## Relevant Information for the Local Planning Panel

**FILE:** D/2017/1552 **DATE:** 3 July 2018

**SUBJECT:** Information Relevant To Item 5 – 26-30 City Road, Chippendale

Figure 1: View from the sun at 9am. The red line shows the height of the fence, corresponding to that of the southern boundary and therefore restricting solar access.

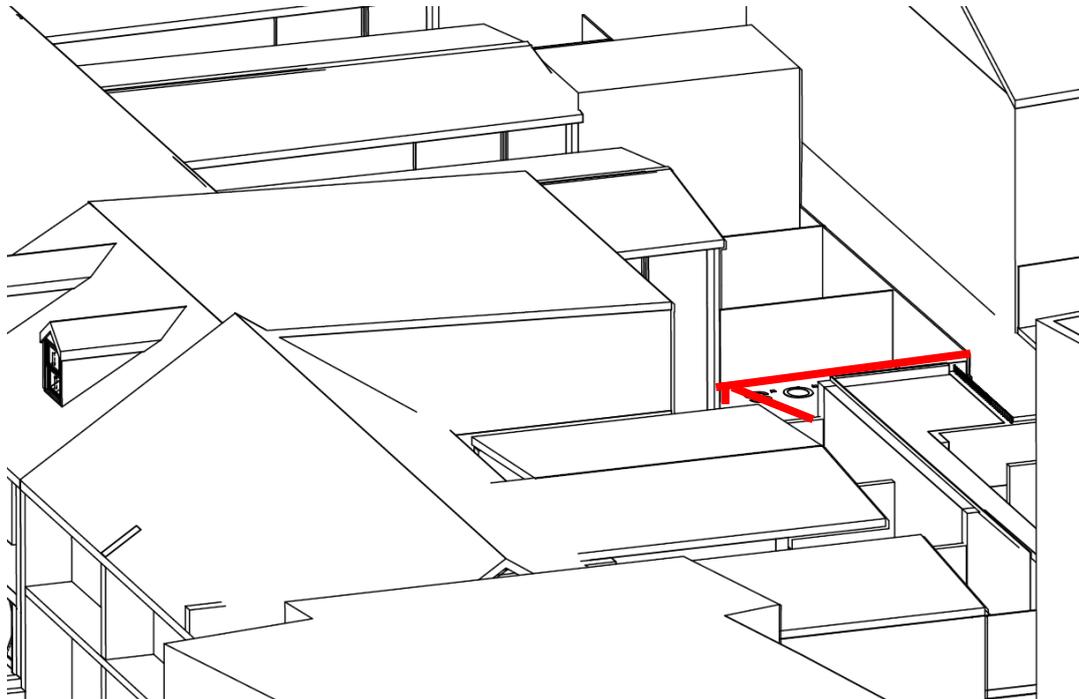
**Response:** The revised solar access diagrams at Attachment B do not accurately represent the existing and proposed built form of the existing Rose Street terraces, particularly regarding the provision of fences. As shown in figure 1 below, the height of the fence on the north boundary of no. 35 Rose Street is not accurately represented. It is noted that the existing ground level at nos. 35 and 37 Rose Street is higher than that at the rear of the proposed terrace houses and as such the fence between the proposed terraces and no. 35 Rose Street is likely to be higher than that shown on the diagrams.

At 10am, solar access to the rear of nos. 35 and 37 will be retained. At 11am solar access to the rear of the terraces will see a slight improvement. However officers are of the opinion that, contrary to the applicant's statement, the rear of the properties do not currently receive solar access at midday and will continue to be overshadowed due to the former Grace Bros. building.

Between 1pm and 3pm, the rear of no. 37 Rose Street currently receives some solar access, which will be lost without the reduction in the scale of the boarding house. This will have a lasting impact not only during midwinter but potentially for the days and weeks either side.

As such, and with regard to the matter of bulk and scale, Council officers reaffirm their assessment in the planner's report that, as the development exceeds the maximum 15 metre Sydney LEP 2012 height standard and 3 storey height control, the development should minimise impacts to the character and amenity of the surrounding area. Reducing the scale of the building will improve solar access to the private open spaces of nos. 35 and 37 Rose Street as well provide a transition in scale from City Road to Rose Street. While the modification will result in the loss of potentially 8 rooms, the development will still provide approximately 65 low rent boarding rooms. The deletion of the condition is not supported.
